COUNTY OF KAUAI
DEPARTMENT OF WATER
2005 AMENDMENTS

*to the 2002 Water System Standards
adopted by the
Hawaii County Department of Water Supply,
City and County of Honolulu Board of Water Supply,
Kauai County Department of Water, and
Maui County Department of Water Supply*

2005 AMENDMENTS
to the 2002 Water System Standards

KAUAI	SINGLE SERVICE LATERAL PLAN, PROFILE & MATERIAL LIST SCALE: NTS	STANDARD DETAILS	L1
-------	-----------------------------------------------------------------------	---------------------	----

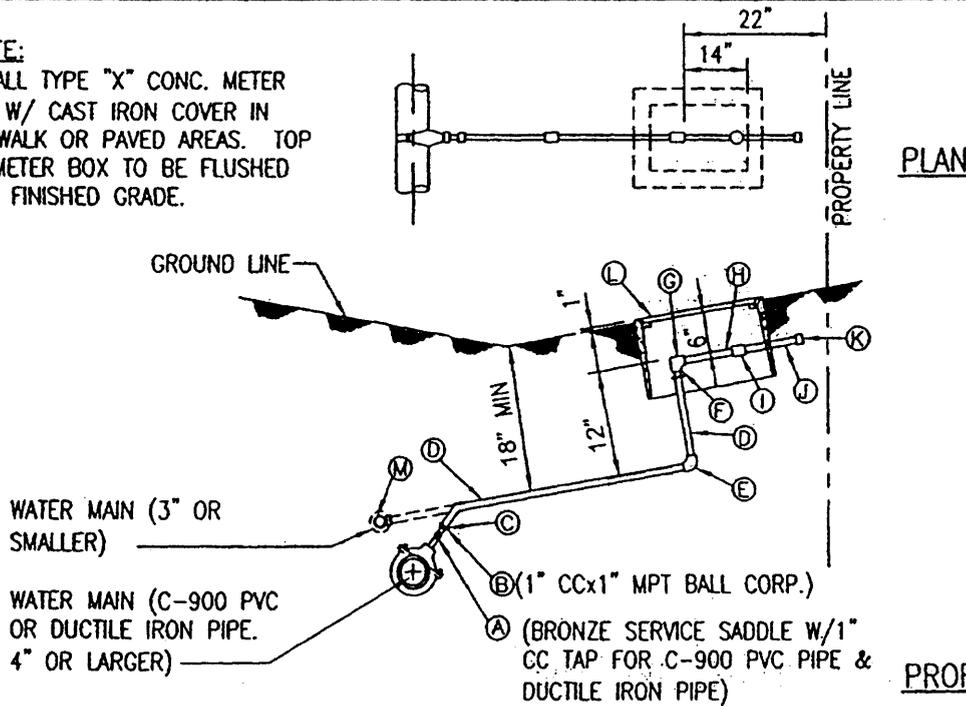
17. **DIVISION 400, Sec. 403 “STANDARD DETAILS”, subsection IV. “Service Laterals (L)”, subdivision A. “Kaua‘i”, detail no. L1**: Division 400, Sec. 403, subsection IV, subdivision A, detail no. L1 is hereby deleted and replaced in its entirety with attached Exhibit “D”, which is incorporated by reference into these 2005 Amendments.

KAUAI	DOUBLE SERVICE LATERAL PLAN, PROFILE & MATERIAL LIST SCALE: NTS	STANDARD DETAILS	L2
-------	------------------------------------------------------------------------------	---------------------	----

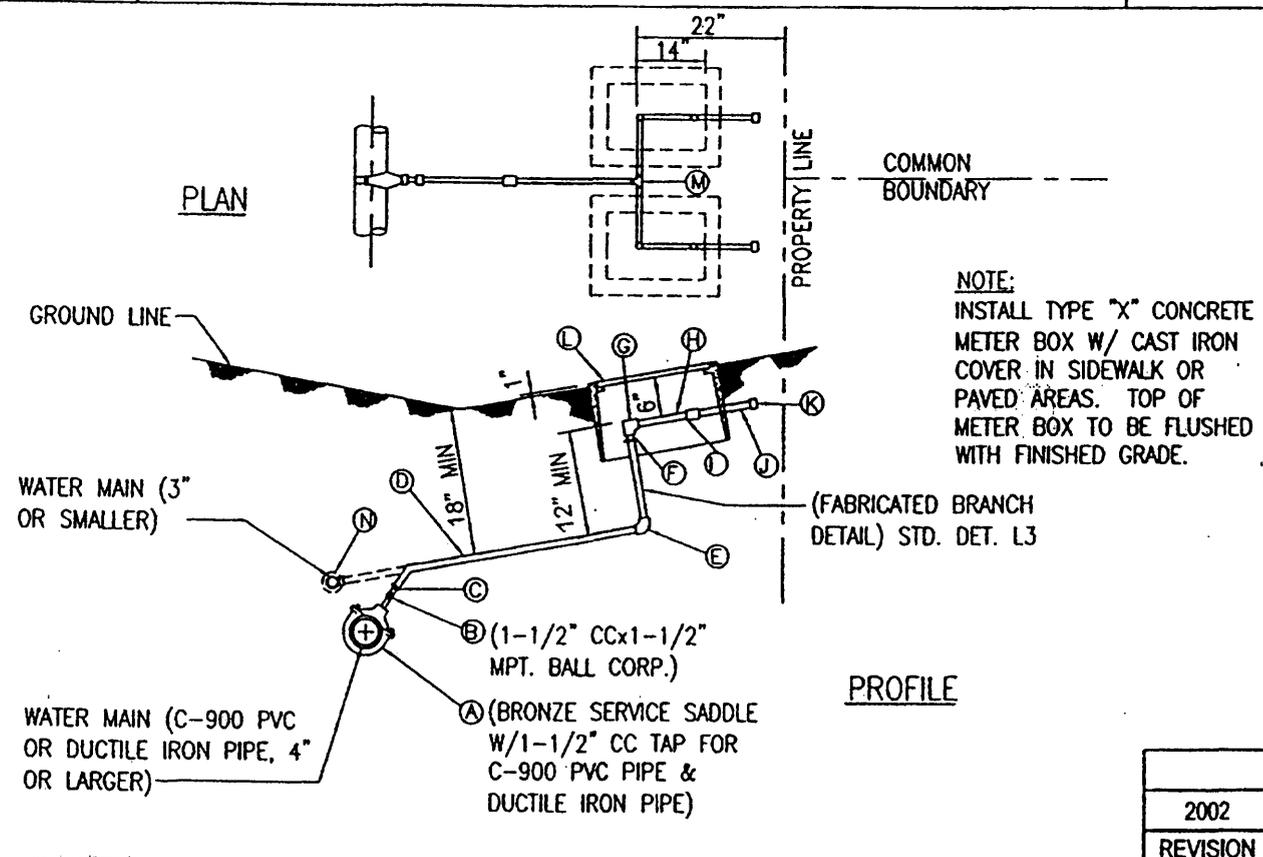
18. **DIVISION 400, Sec. 403 “STANDARD DETAILS”, subsection IV. “Service Laterals (L)”, subdivision A. “Kaua‘i”, detail no. L2**: Division 400, Sec. 403, subsection IV, subdivision A, detail no. L2 is hereby deleted and replaced in its entirety with attached Exhibit “E”, which is incorporated by reference into these 2005 Amendments.

KAUAI	ONE INCH METER PROFILE & MATERIAL LIST SCALE: NTS	STANDARD DETAILS	L4
-------	----------------------------------------------------------------	---------------------	----

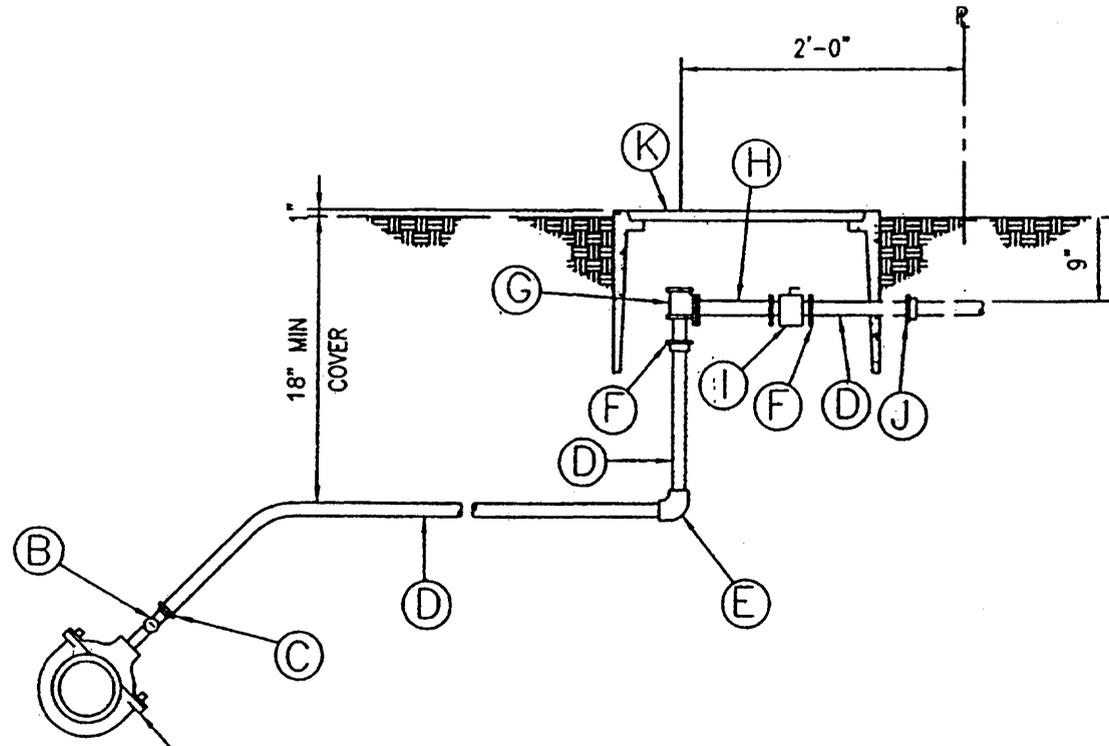
19. **DIVISION 400, Sec. 403 “STANDARD DETAILS”, subsection IV. “Service Laterals (L)”, subdivision A. “Kaua‘i”, detail no. L4**: Division 400, Sec. 403, subsection IV, subdivision A, detail no. L4 is hereby deleted and replaced in its entirety with attached Exhibit “F”, which is incorporated by reference into these 2005 Amendments.

KAUAI	1 1/2" INCH METER PROFILE & MATERIAL LIST SCALE: NTS	STANDARD DETAILS	18" L5
-------	-------------------------------------------------------------------	---------------------	-----------

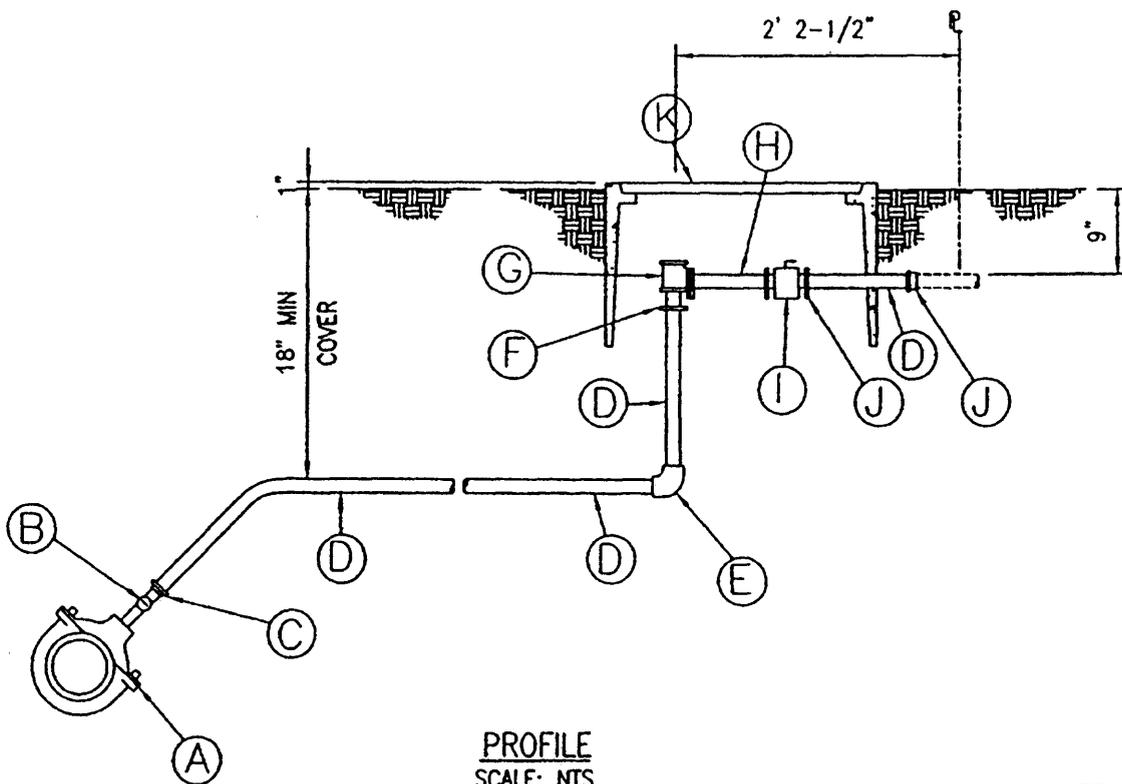
20. **DIVISION 400, Sec. 403 “STANDARD DETAILS”, subsection IV. “Service Laterals (L)”, subdivision A. “Kaua‘i”, detail no. L5**: Division 400, Sec. 403, subsection IV, subdivision A, detail no. L5 is hereby deleted and replaced in its entirety with attached Exhibit “G”, which is incorporated by reference into these 2005 Amendments.

KAUAI	TWO-INCH METER PROFILE & MATERIAL LIST SCALE: NTS	STANDARD DETAILS	L6
-------	---------------------------------------------------------------------	---------------------	-----------

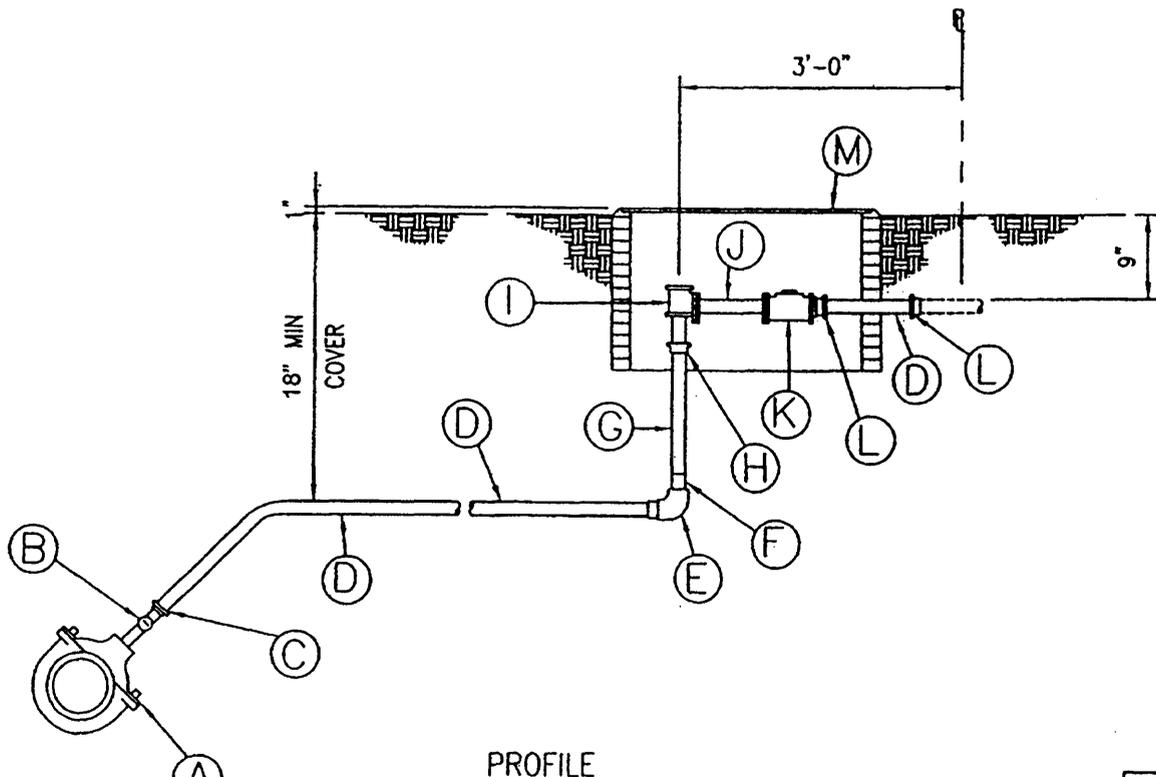
21. **DIVISION 400, Sec. 403 “STANDARD DETAILS”, subsection IV. “Service Laterals (L)”, subdivision A. “Kaua‘i”, detail no. L6**: Division 400, Sec. 403, subsection IV, subdivision A, detail no. L6 is hereby deleted and replaced in its entirety with attached Exhibit “H”, which is incorporated by reference into these 2005 Amendments.

KAUAI	WATERLINE TRENCH DETAILS MISCELLANEOUS DETAILS SCALE: NTS	STANDARD DETAILS	P11
-------	------------------------------------------------------------------------	------------------	-----

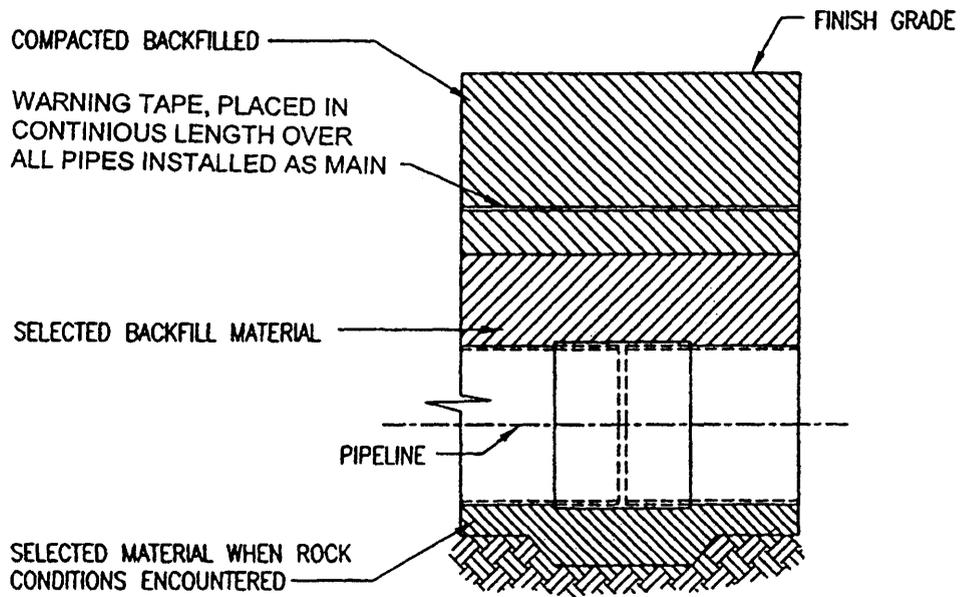
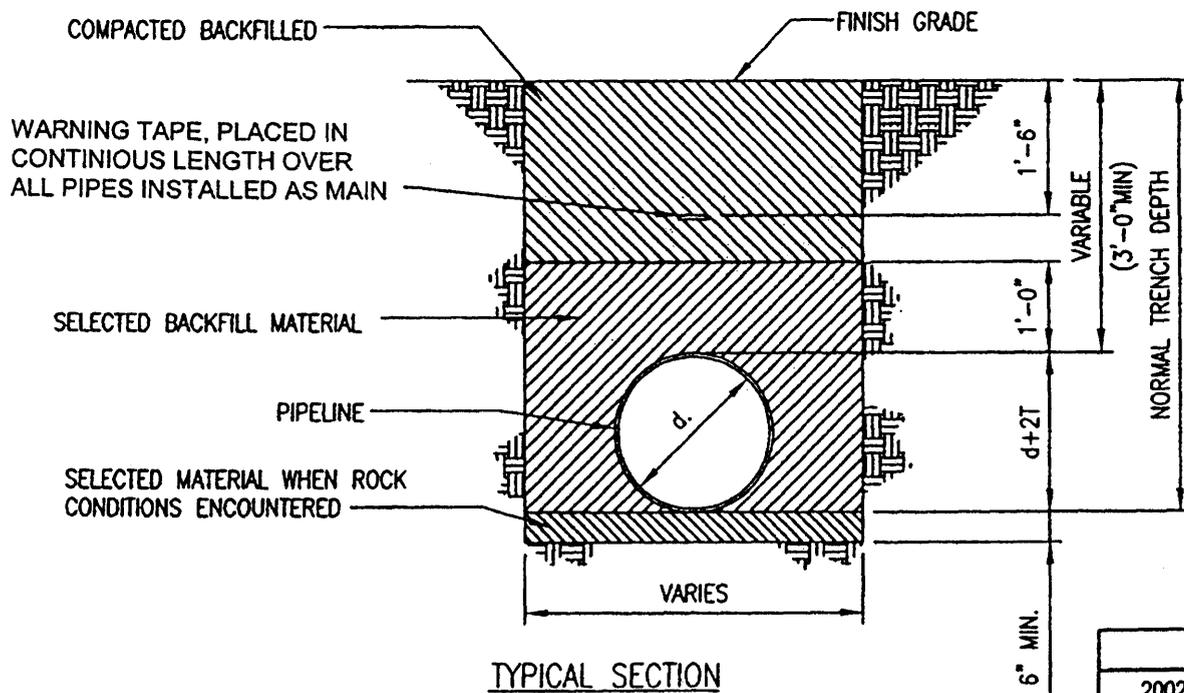
22. **DIVISION 400, Sec. 403 “STANDARD DETAILS”, subsection VII. “Trench Details, and Concrete Cylinder Pipe and Appurtenances (P)”, subdivision C. “Trench Details”, detail no. P11**: Division 400, Sec. 403, subsection VII, subdivision C, detail no. P11 is hereby deleted and replaced in its entirety with attached Exhibit “I”, which is incorporated by reference into these 2005 Amendments.

KAUAI	CAST IRON VALVE BOX DETAILS	STANDARD DETAILS	V11
SCALE: NTS

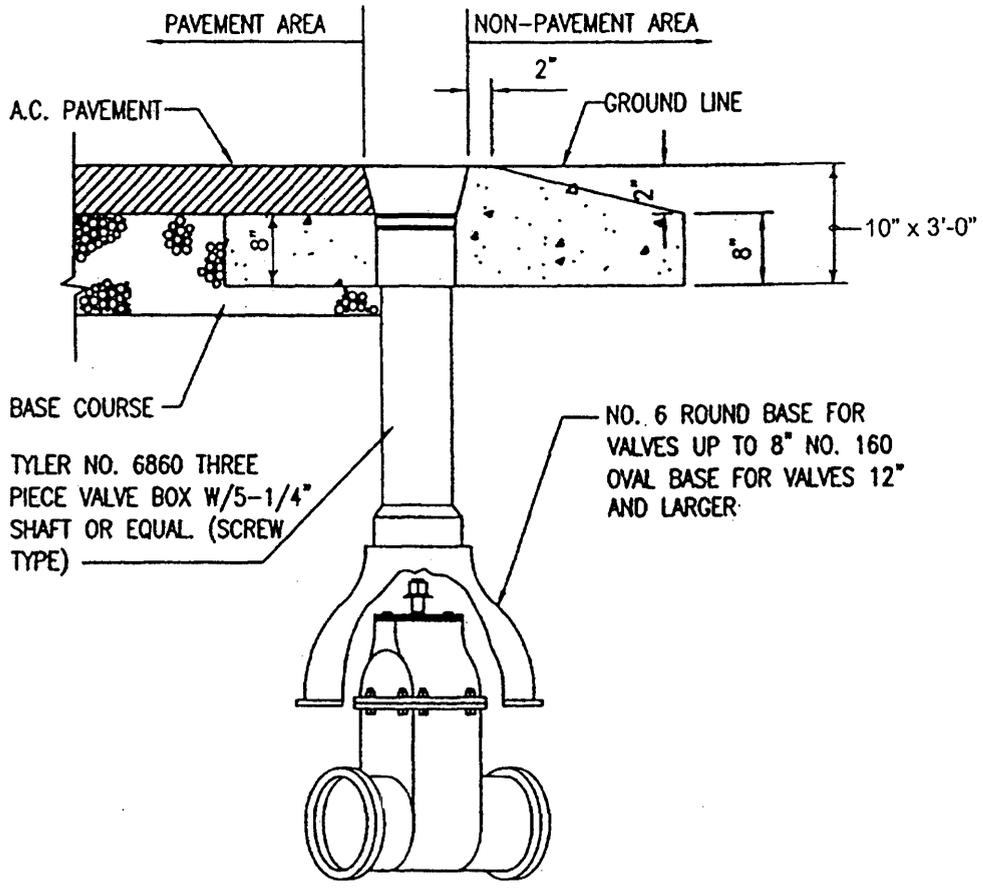
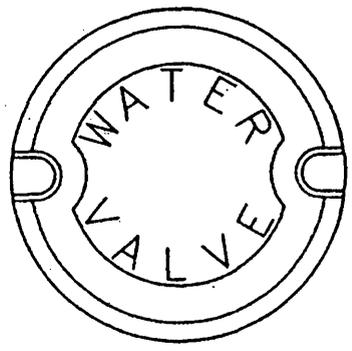
23. **DIVISION 400, Sec. 403 “STANDARD DETAILS”, subsection VIII. “Valves and Appurtenances (V)”, subdivision D. “Valve Box Installation and Miscellaneous Details”, detail no. V11**: Division 400, Sec. 403, subsection VIII, subdivision D, detail no. V11 is hereby deleted and replaced in its entirety with attached Exhibit “J”, which is incorporated by reference into these 2005 Amendments.

KAUAI OAHU HAWAII	12" VALVE BOX INSTALLATION FOR GATE VALVE SCALE: NTS	STANDARD DETAILS	V14
-------------------------	--------------------------------------------------------------------	---------------------	-----

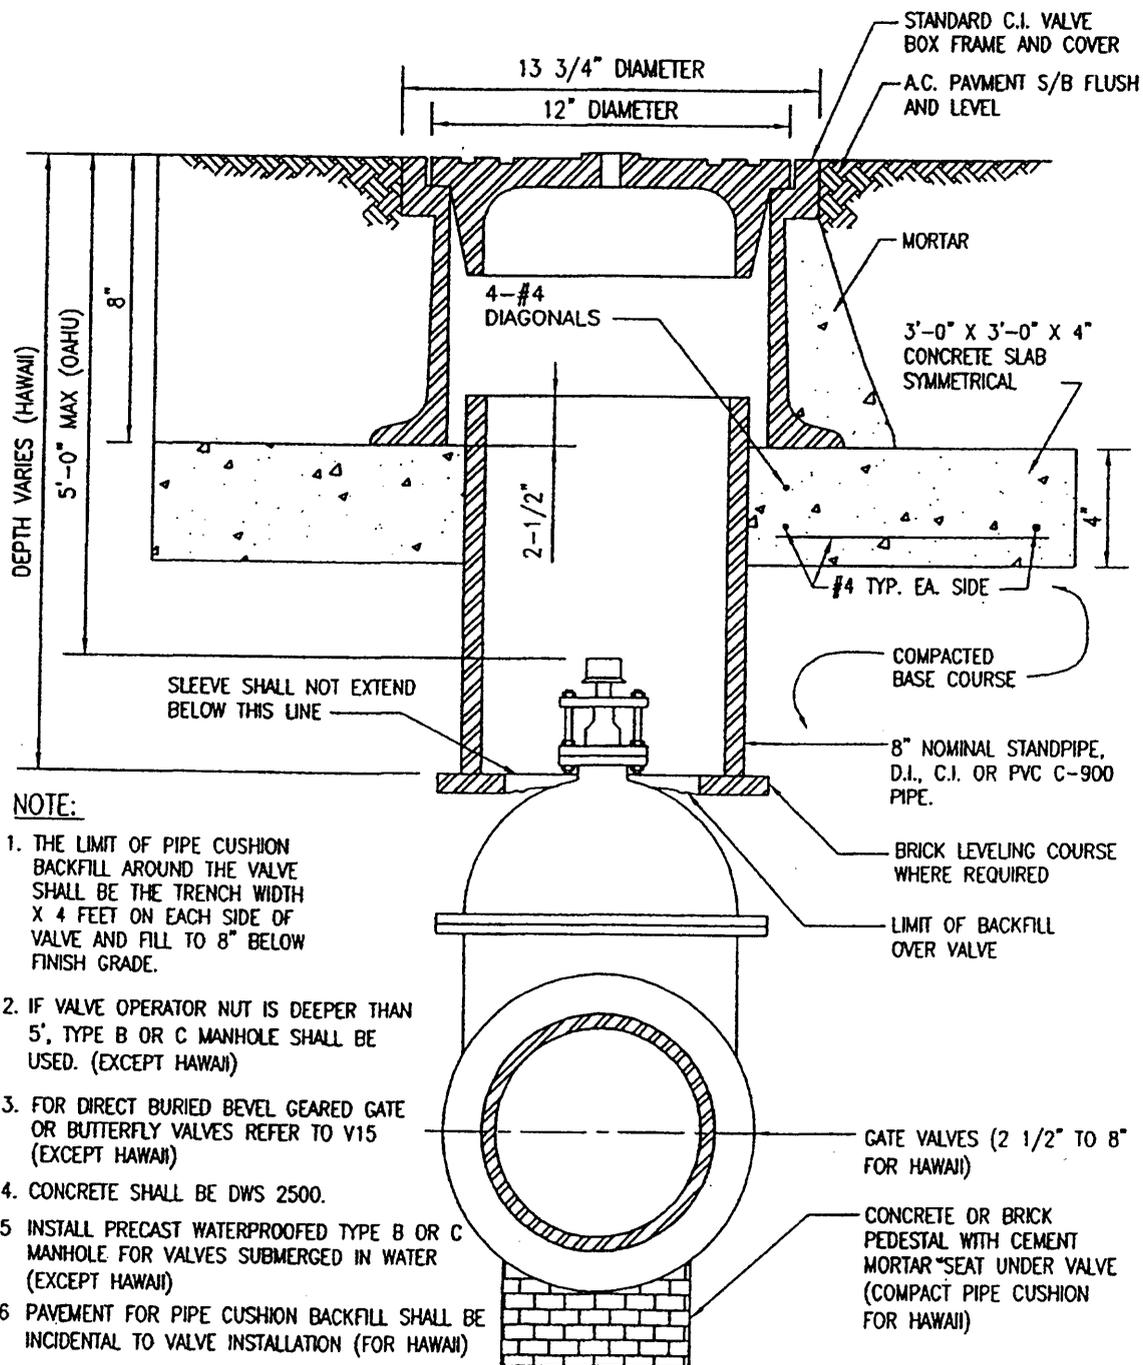
25. DIVISION 400, Sec. 403 “STANDARD DETAILS”, subsection VIII. “Valves and Appurtenances (V)”, subdivision D. “Valve Box Installation and Miscellaneous Details”, detail no. V14: Division 400, Sec. 403, subsection VIII, subdivision D, detail no. V14 is hereby deleted and replaced in its entirety with attached Exhibit “K”, which is incorporated by reference into these 2005 Amendments.

KAUAI OAHU MAUI HAWAII	12" VALVE BOX INSTALLATION FOR VALVE OPERATORS SCALE: NTS	STANDARD DETAILS	2002
			REVISION
			V15

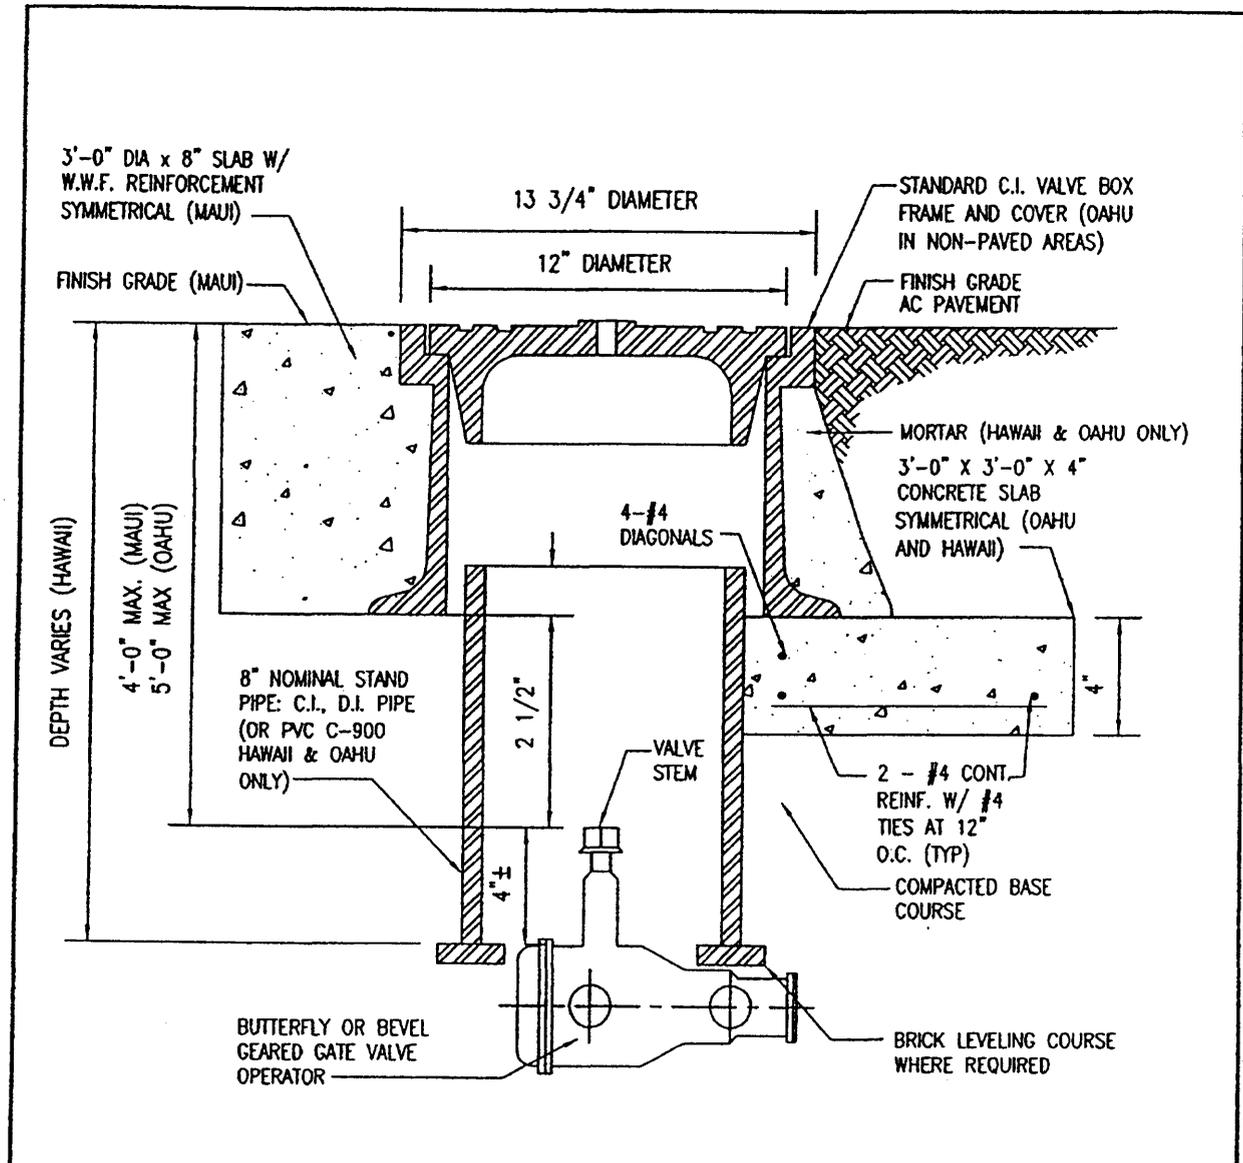
26. DIVISION 400, Sec. 403 “STANDARD DETAILS”, subsection VIII. “Valves and Appurtenances (V)”, subdivision D. “Valve Box Installation and Miscellaneous Details”, detail no. V15: Division 400, Sec. 403, subsection VIII, subdivision D, detail no. V15 is hereby deleted and replaced in its entirety with attached Exhibit “L”, which is incorporated by reference into these 2005 Amendments.
